MITSUBISHI MOTORS

SERVICE BULLETIN

PURPOSE : INFORMATION	ISSUE NO. : MSB-11E27-001B	DATE : 2012-07-11
SUBJECT : REAR DIFFERENTIAL GEAR OIL QUANTITY		<MODEL> <M/Y>
GROUP : REAR AXLE		(EUR/RUSSIA) See following 2. Applicable Manuals table.

According to the change in the rear differential gear oil quantities, the service procedures have been changed in the applicable Workshop Manuals. This Service Bulletin contains the modified descriptions.

<Old> **GEAR OIL LEVEL CHECK**

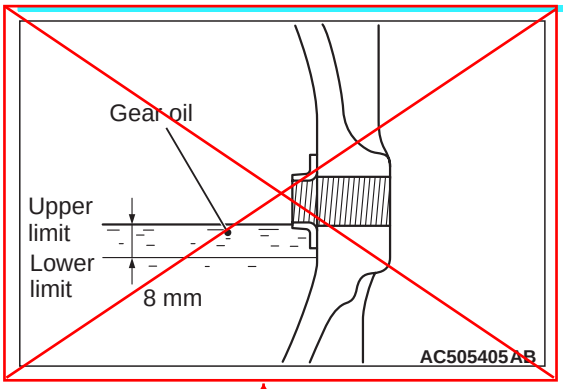
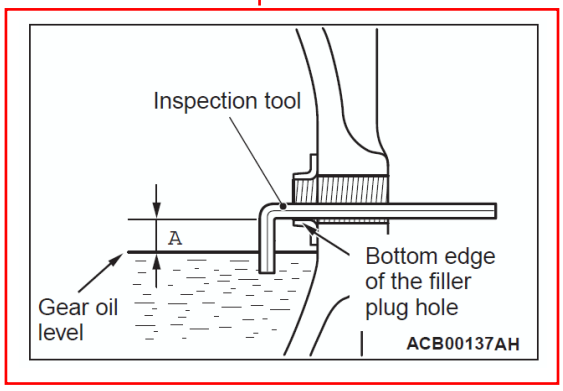
1. Check that gear oil level is not 8 mm below the bottom of filler plug hole.
2. If the gear oil level is lower than the lower limit, add the specified gear oil until the level comes to the lower portion of the filler plug hole.

CAUTION
Be careful not to drop the inspection tool into the differential.

1. Insert an inspection tool as shown so that it touches the bottom of the filler plug.
   Inspection tool: 6 mm-diameter L shaped bar (e.g. 6 mm-diameter angled hexagon wrench)
2. Pull out the wrench, and then check that the dimension to the gear oil level is within 24 mm.

Insert the attached sheet 35-A

<New>
4. Refill the gear oil until the level satisfies the specification.

GEAR OIL REPLACEMENT

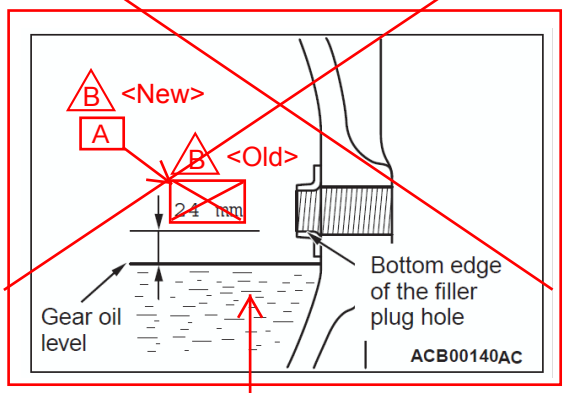
Specified gear oil:
Gear oil API classification GL-5 or higher SAE 80W
Amount to use:
1.5L <2WD (except High rider)>
2.6L <2WD (High rider), 4WD (5A/T or except vehicles with High power engine)>
3.2L <Vehicles with High power engine except 5A/T>

<Added>
<Old>
<New>
<Old>
<Old>
<New>
2.1 L
Insert the attached sheet 35-C
B <Added>

REAR DIFFERENTIAL

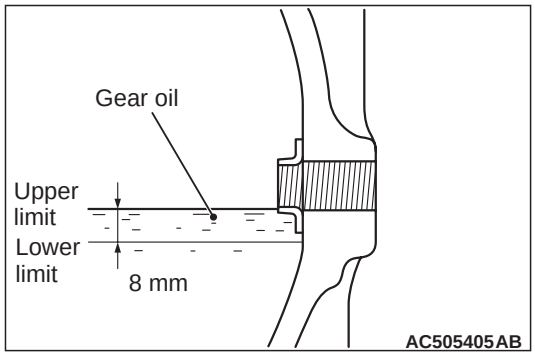
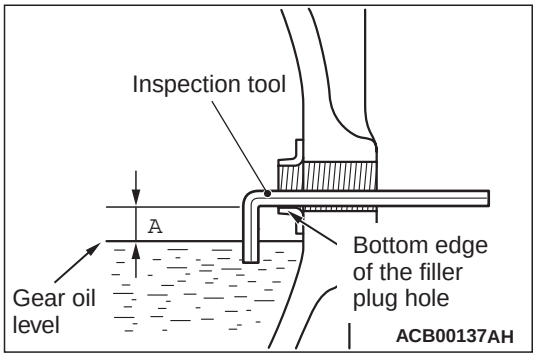
~~1. Insert an inspection tool as shown so that it touches the bottom of the filler plug. The inspection tool: 6 mm-diameter L shaped bar (e.g. 6 mm-diameter angled hexagon wrench).~~
~~2. Pull out the wrench, and then check that the dimension to the gear oil level is within 24 mm.~~

Insert the attached sheet 35-A

REAR DIFFERENTIAL

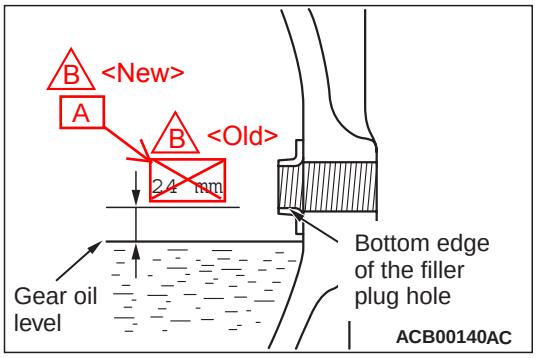
4. Refill the gear oil until the level satisfies the specification.
   Specified gear oil:
   Gear oil API classification GL-5 or higher SAE 80W
   Amount to use:
   1.5 L <2WD (except High rider)>
   2.1 L <2WD (High rider), 4WD (5A/T or except vehicles with High power engine)>
   2.1 L <Vehicles with High power engine except 5A/T>
5. Tighten the filler plug to the specified torque.
   Tightening torque: 50 ± 10 N·m

Insert the attached sheet 35-C

GEAR OIL LEVEL CHECK

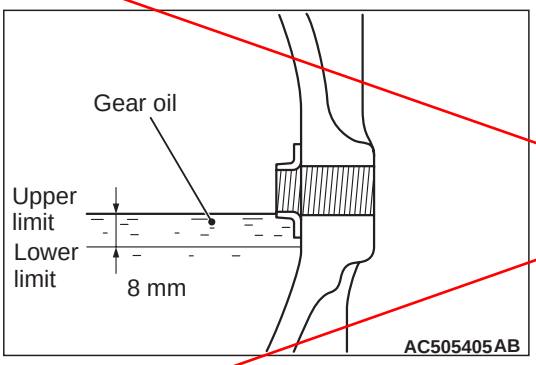
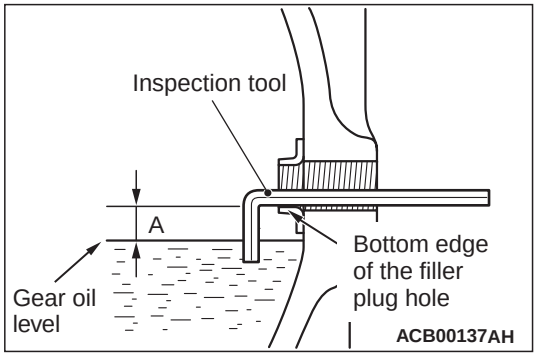
1. Insert an inspection tool as shown so that it touches the bottom of the filler plug. The inspection tool: 6 mm-diameter L shaped bar (e.g. 6 mm-diameter angled hexagon wrench).
2. Pull out the wrench, and then check that the dimension to the gear oil level is within 24 mm.

<Old>
Specified gear oil:
Gear oil API classification GL-5 or higher SAE 80W

Insert the attached sheet 35-A
<New>

GEAR OIL REPLACEMENT

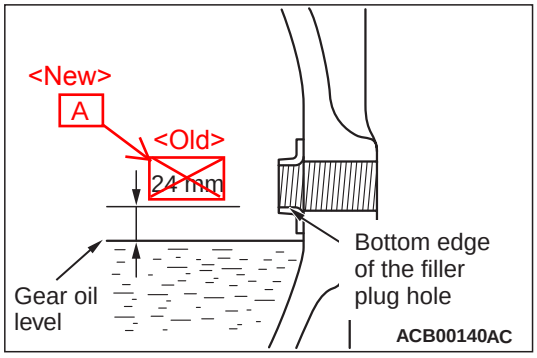
Specified gear oil:
   Gear oil API classification GL-5 or higher SAE 80W
   Amount to use:
   1.5 L <2WD (except High rider)>
   2.1 L <2WD (High rider), 4WD (5A/T or except vehicles with High power engine)>
   2.1 L <Vehicles with High power engine except 5A/T>
5. Tighten the filler plug to the specified torque (Refer to).

Insert the attached sheet 35-C

GEAR OIL LEVEL CHECK

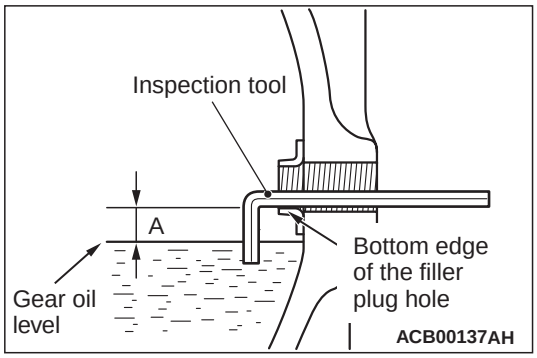
1. Insert an inspection tool as shown so that it touches the bottom of the filler plug. The inspection tool: 6 mm-diameter L shaped bar (e.g. 6 mm-diameter angled hexagon wrench).
2. Pull out the wrench, and then check that the dimension to the gear oil level is within 24 mm.

Insert the attached sheet 35-A

GEAR OIL REPLACEMENT

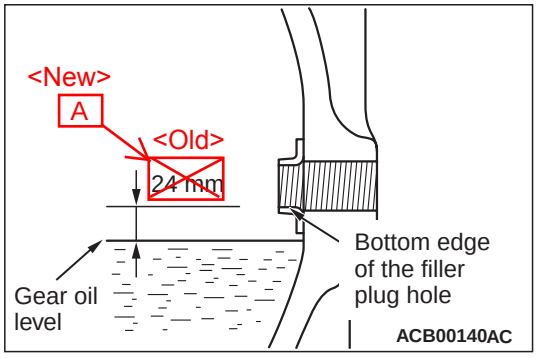
4. Refill the gear oil until the level satisfies the specification.

Specified gear oil:
   MITSUBISHI MOTORS GENUINE Super Hypoid Gear Oil API classification GL-5 SAE 80 or SAE 90
   Amount to use:
   <Except high power engine (2WD with 15 inch tyres)> 1.5 L
   <Except high power engine (2WD with 16 inch tyres, 4WD)> 2.1 L
   <High power engine> 2.1 L

Insert the attached sheet 35-C
<Added>

REAR DIFFERENTIAL

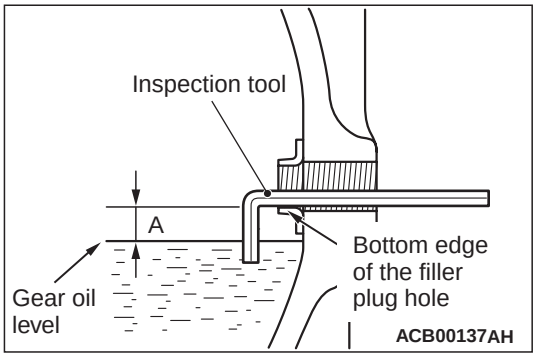
<Old>
~~1. Insert an inspection tool as shown so that it touches the bottom of the filler plug. The inspection tool: 6 mm-diameter L shaped bar (e.g. 6 mm-diameter angled hexagon wrench).~~
~~2. Pull out the wrench, and then check that the dimension to the gear oil level is within 24 mm.~~

<New>
Insert the attached sheet 35-A

REAR DIFFERENTIAL

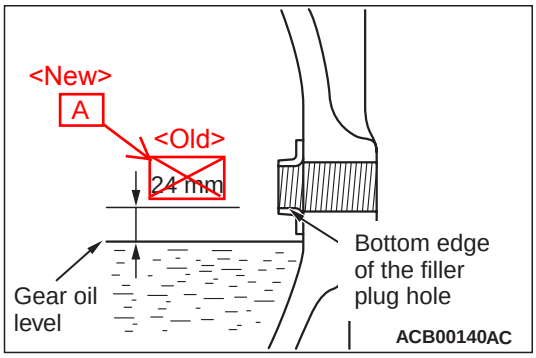
4. Refill the gear oil until the level satisfies the specification.
   Specified gear oil:
   Gear oil API classification GL-5 or higher SAE 80W
   Amount to use:
   1.5 L <2WD (except High rider)>
   2.1 L <2WD (High rider), 4WD (5A/T or except vehicles with High power engine)>
   2.1 L <Vehicles with High power engine except 5A/T>
5. Tighten the filler plug to the specified torque.
   Tightening torque: 50 ± 10 N·m

Insert the attached sheet 35-C
<Added>

REAR DIFFERENTIAL

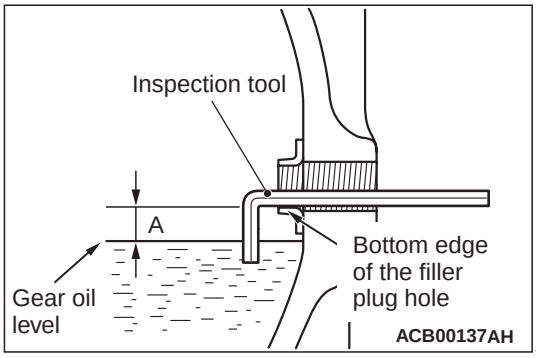
<Old>
1. Insert an inspection tool as shown so that it touches the bottom of the filler plug. The inspection tool: 6 mm-diameter L shaped bar (e.g. 6 mm-diameter angled hexagon wrench).
2. Pull out the wrench, and then check that the dimension to the gear oil level is within 24 mm.

<New>
Insert the attached sheet 35-A

REAR DIFFERENTIAL

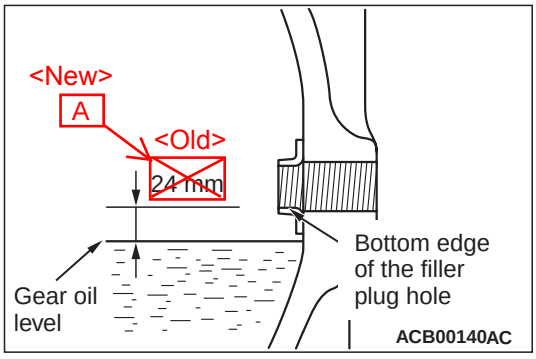
4. Refill the gear oil until the level satisfies the specification.
Specified gear oil:
MITSUBISHI MOTORS GENUINE Super Hypoid Gear oil API classification GL-5 SAE 80 or SAE 90
Amount to use:
1.5 L <Except high power engine (2WD with 15 inch tyres)>
2.1 L <Except high power engine (2WD with 16 inch tyres, 4WD)>
2.1 L <High power engine>
5. Tighten the filler plug to the specified torque.
Tightening torque: 50 ± 10 N·m

Insert the attached sheet 35-C
<Added>
